Inland Transport Committee

Proposal for amendments to Regulation No. 10 (Electromagnetic compatibility)

Submitted by the expert from Belgium*

The text reproduced below was prepared by the expert from Belgium to amend Regulation No. 10 with prescriptions for trolleybuses. It is based on GRE-71-26 introduced at the seventy-first session of GRE. The modifications to the existing text of the Regulation are marked in bold for new or strikethrough for deleted characters.

(b) Vehicle broadband reference limits
Antenna vehicle - overhead contact line separation 10 m

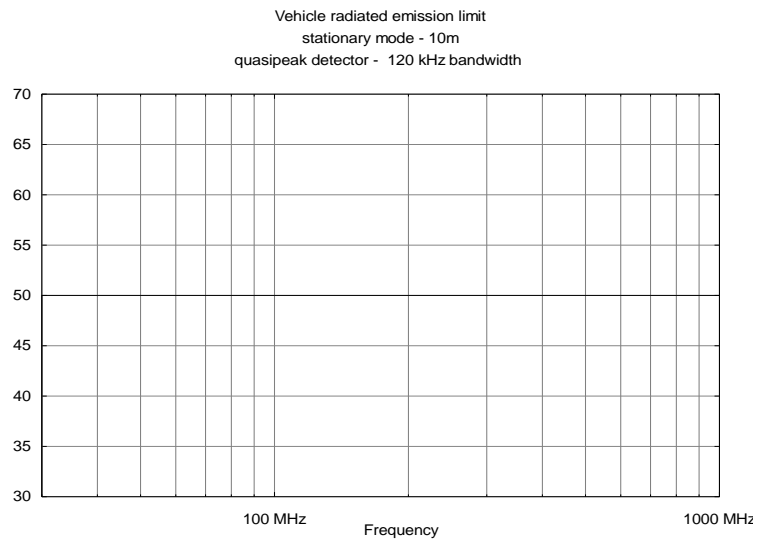
Limit E (dBμV/m) at frequency F (MHz):
30 – 1 000 MHz
E = 50

(c) **Vehicle broadband reference limits**
Antenna vehicle - overhead contact line separation 10 m

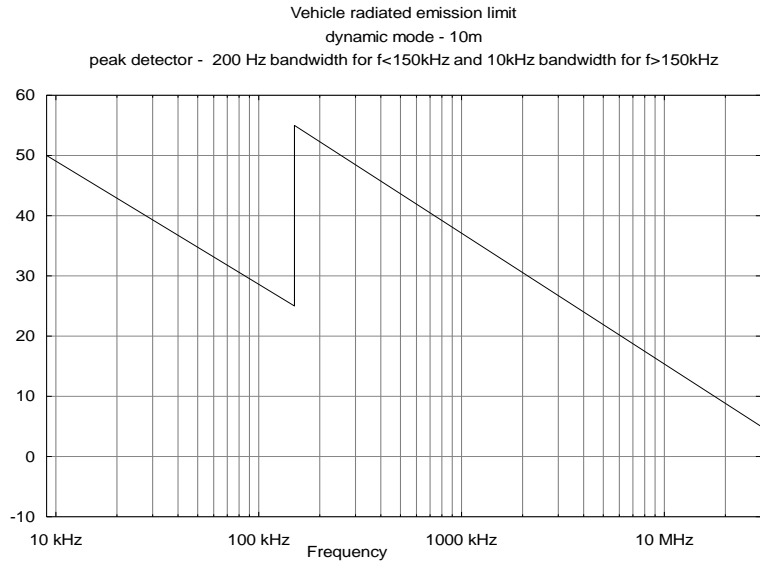
Limit H (dBμA/m) at frequency F (MHz):	
0.009 – 0.150 MHz	0.150 – 30 MHz
$H = 50 - 20.46 \cdot \log (F / 0.009)$	$H = 55 - 21.73 \cdot \log (F / 0.15)$

(d) **Vehicle broadband reference limits**
Antenna vehicle - overhead contact line separation 10 m

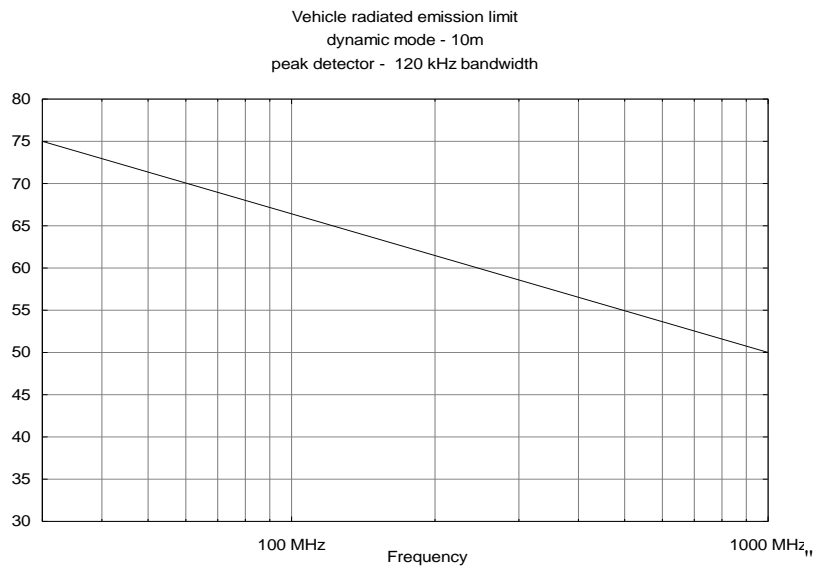
Limit E (dBμV/m) at frequency F (MHz)
30 – 1 000 MHz
$E = 75 - 16.42 \cdot \log (F / 30)$
